Minutes of a Special meeting of the Planning and Highways Committee held by Virtual Meeting on Zoom Monday 10th August 2020 at 7.00pm.

The Chairperson welcomed everyone to the special meeting of the Planning & Highways Committee to consider Planning Application: 20/20/01238/OUTMAJ for Sandleford Park, Newtown Road, Newtown, Newbury for Bloor Homes & Sandleford Farm Partnership.

Sandleford Joint Working Group

Recommendations to Newbury Town Council and Greenham Parish Council re Planning Application ref. no: 20/01238/OUTMAJ

Andrews et al 2019 (Arboricultural Journal)

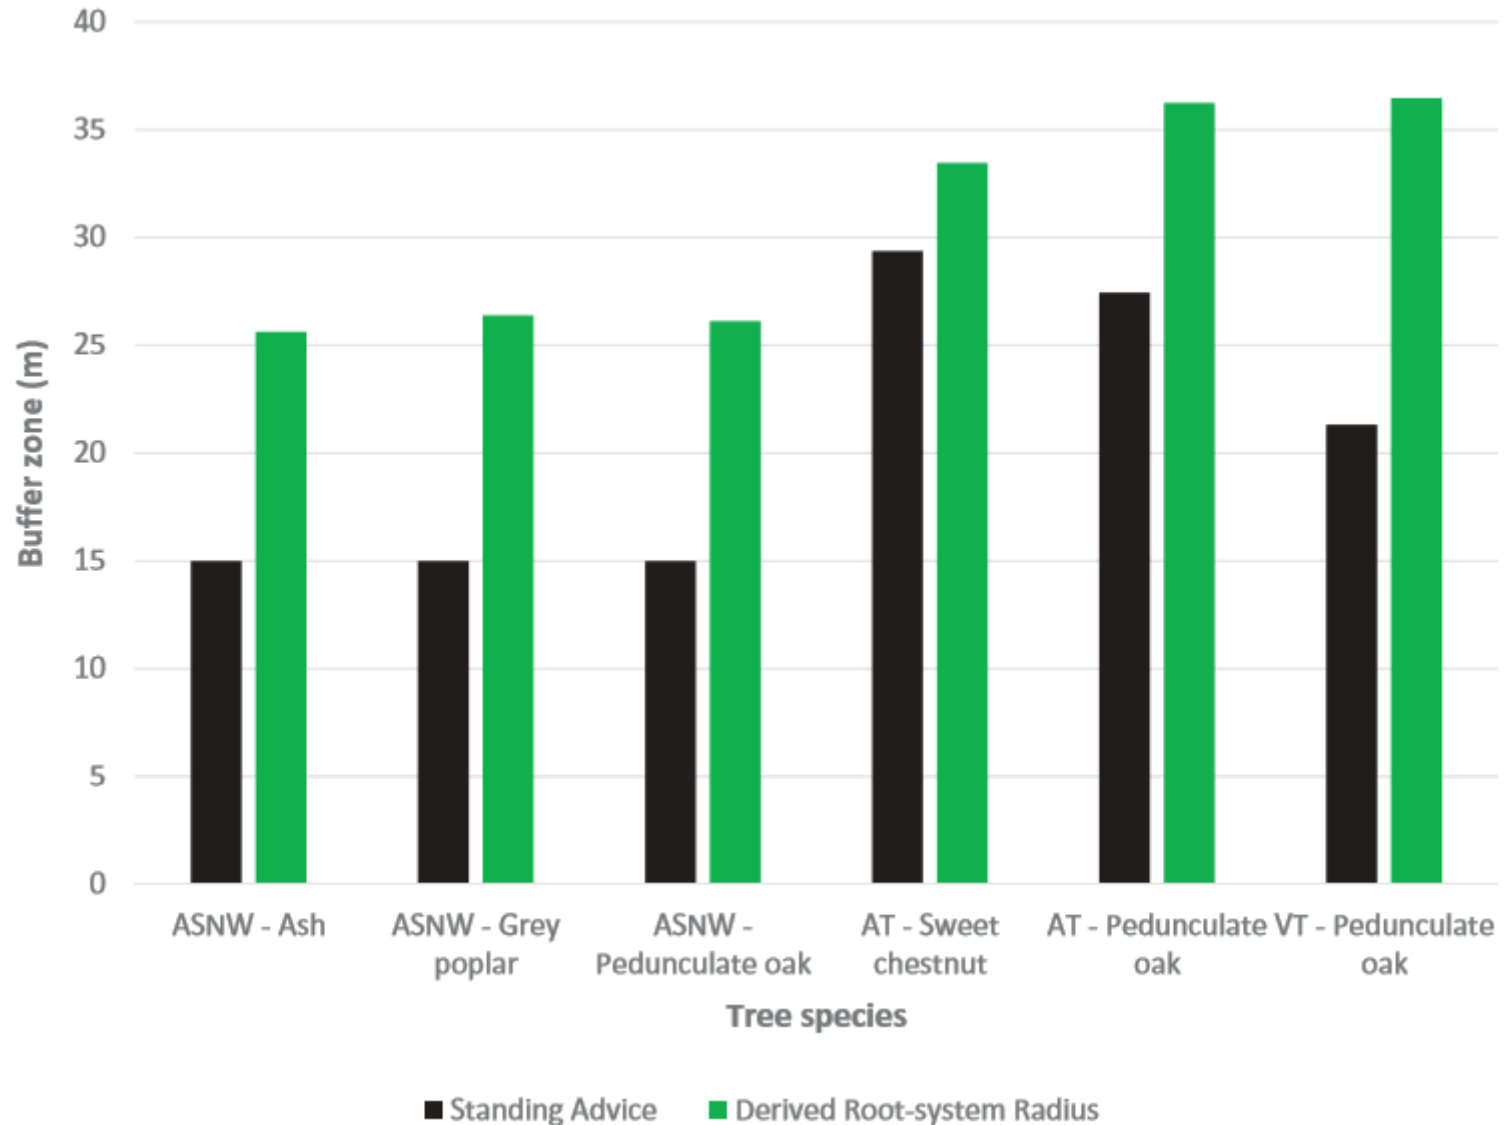
Compares standing advice buffer zones to actual root system size

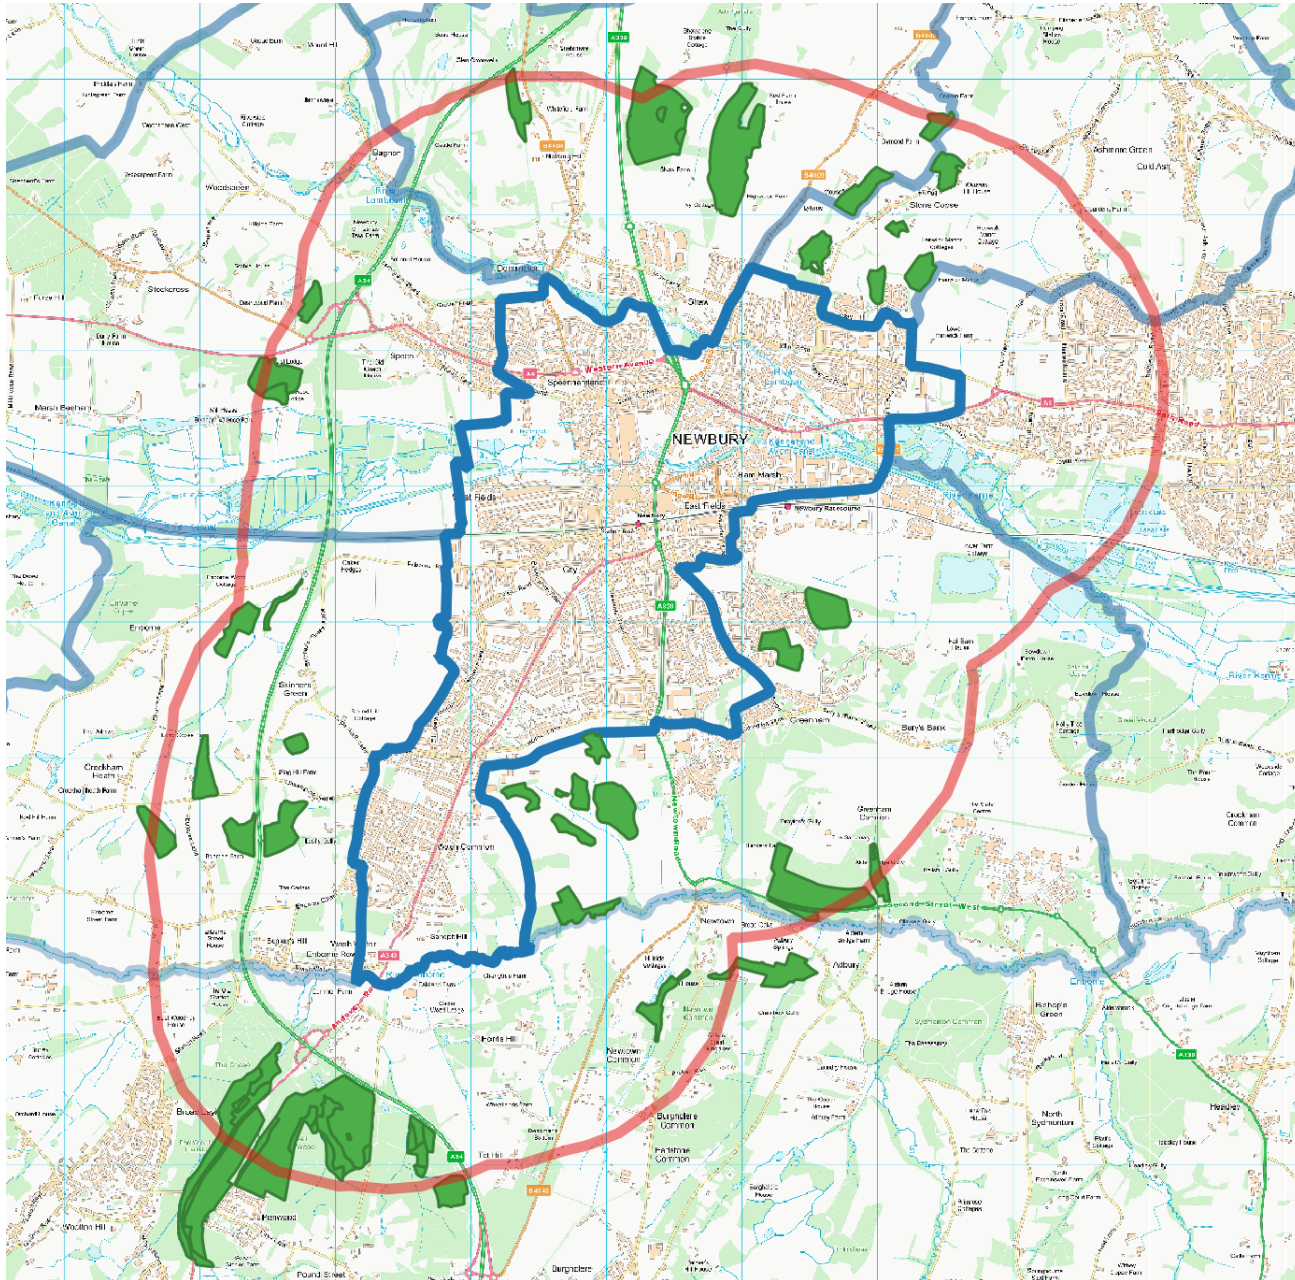
"It is considered that a **buffer of greater than 15m would be appropriate for the ancient woodland on this site and that a buffer of 30m would be appropriate in areas where the ancient woodland is immediately adjacent to the built development.....**

We therefore recommend that a buffer zone of greater than 15m should encompass all ancient woodlands within this site and **a buffer zone of 30m should be imposed at points where the ancient woodland is immediately adjacent to built development.**

If this development were to proceed **with the currently proposed 15m buffer zone**, it is likely that these ancient woodlands will deteriorate for the reasons stated above **and the Council will fail to meet its statutory obligations under the Natural Environment and Rural Communities Act (2006)* and will fail to meet the policy objectives of both the NPPF and West Berkshire Core Strategy."**

Sandleford 'Green Infrastructure' plan (submitted by Bloor) in context

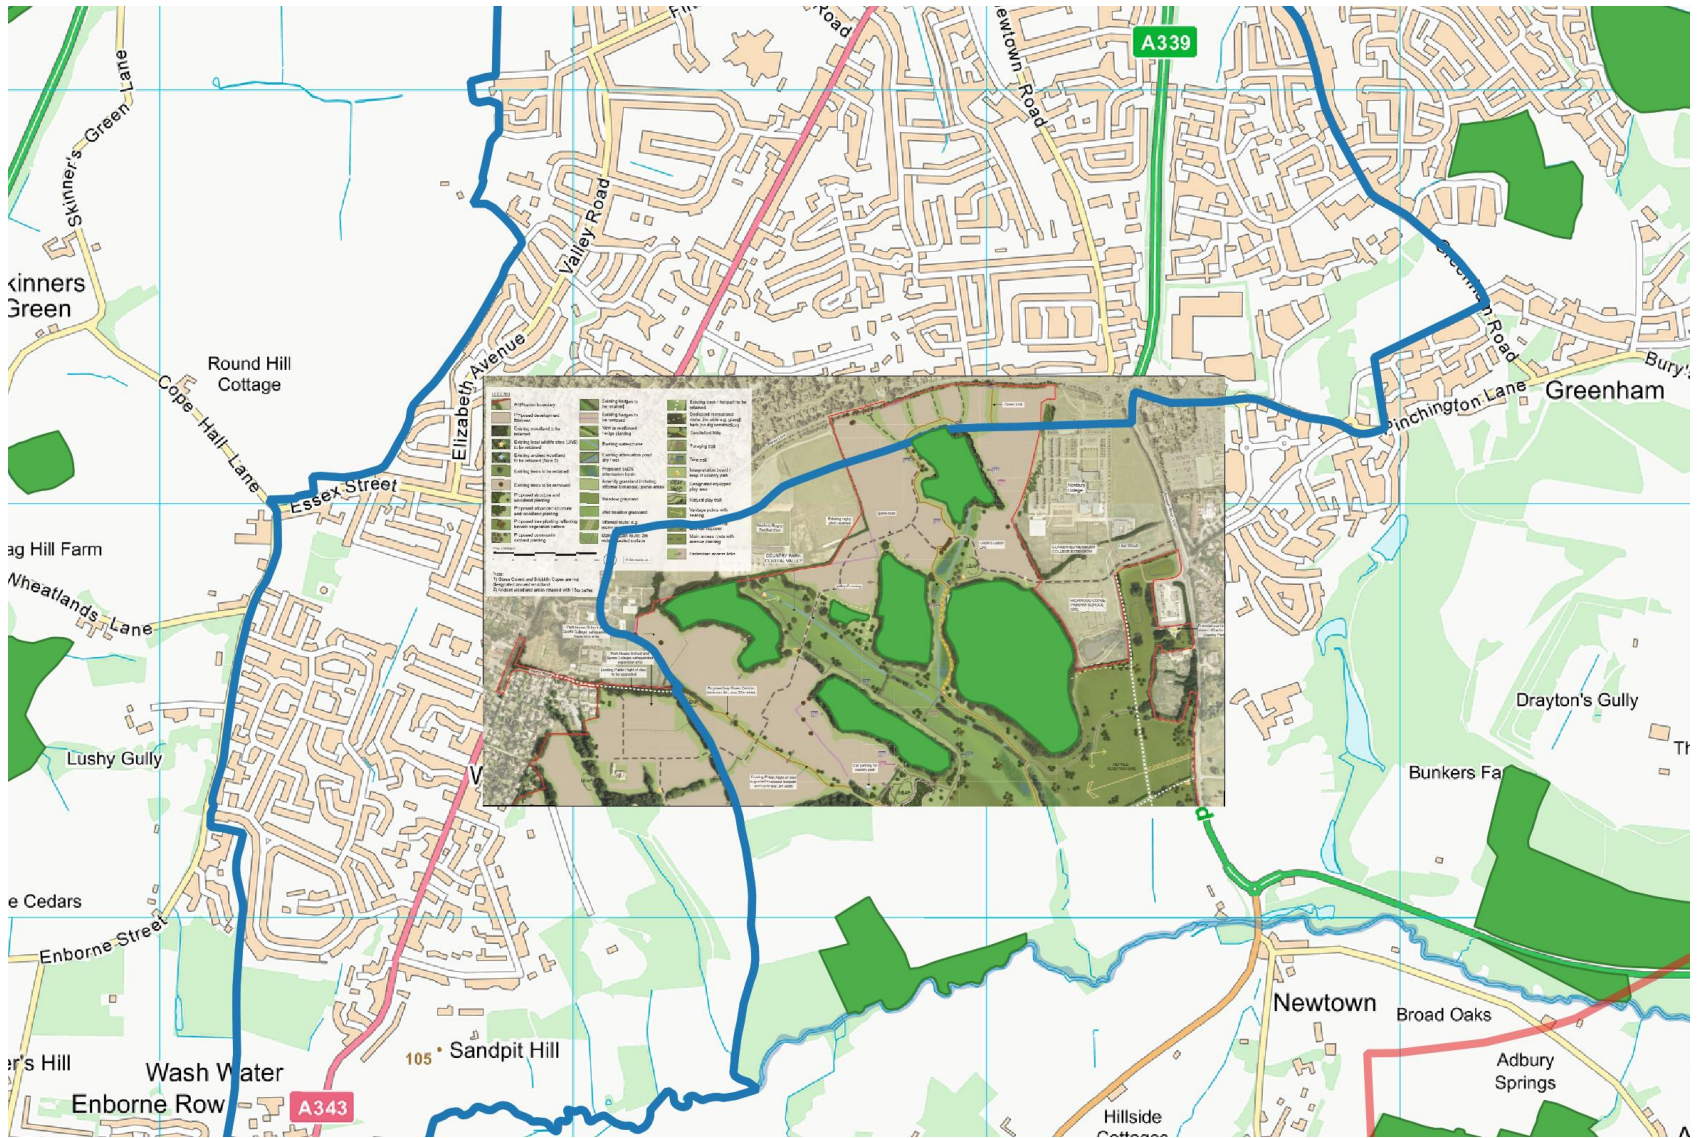
Newbury ancient woodland network (dark green)

Ancient Woodland Mitigation

- Fenced 15 metre buffer zones
- Holly management to improve habitat
- Dead wood left in situ 'minimum amount removed concordant with public safety'
- Footpaths 'largely follow existing tracks' and to be mapped for reserved matters apps
- Boardwalks in wet areas (see next slide/page)
- 'Not considered that ancient woodland indicators will be impacted as they are located along existing tracks'
- 'Areas cleared of bramble and sycamore' (some bramble is beneficial for nesting and nectar)
- Information boards and possibly fencing
- Monitoring of bluebell populations. **"No further monitoring is proposed"**.
